Assessment of Dam Safety Coal Combustion Surface Impoundments (Task 3) Draft Report

Duke Energy Corporation

Belews Creek
Steam Station

Walnut Cove, North Carolina

PROJECT NO. 20085
DATE: 10/2009
FIGURE 5

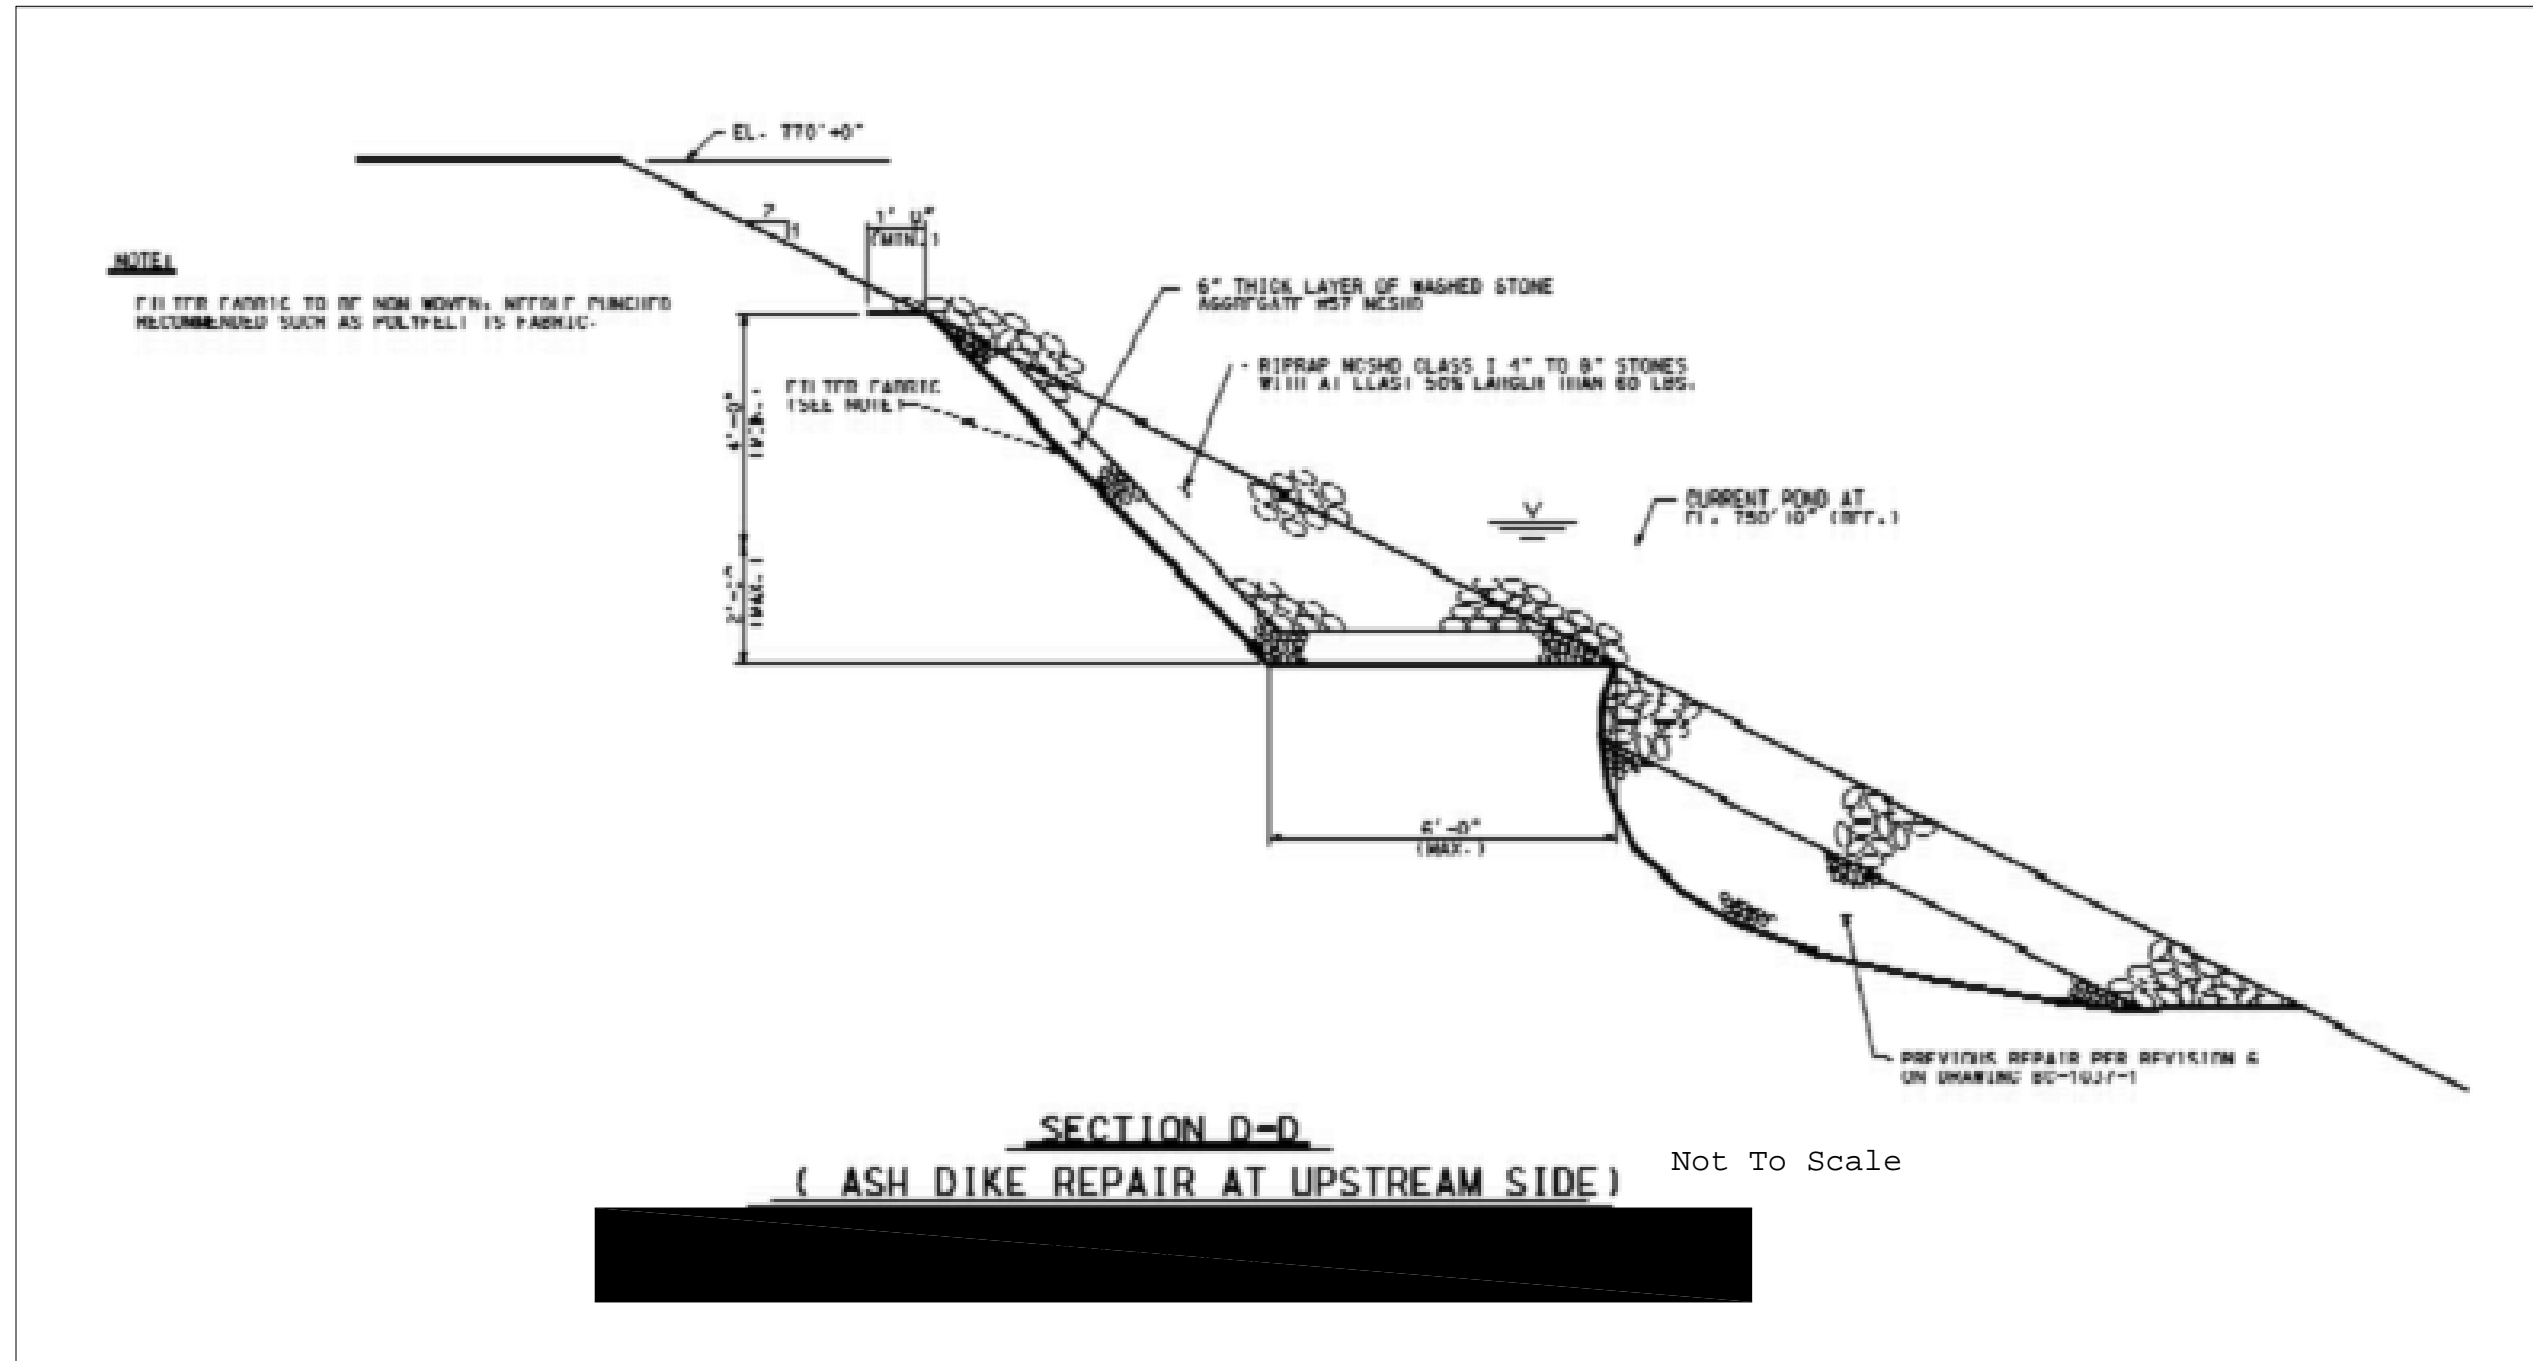
- March 19, 1984: Additional analysis completed by Duke Energy considering slope stability and the proposed horizontal drain installation. Stability analyses were run under the steady state seepage condition using new soil strength parameters. Safety factors ranged from 1.37 to 1.46 depending on reservoir elevation and the variation in soil parameters used. The horizontal drain design is developed and is partially shown on Figure 5.
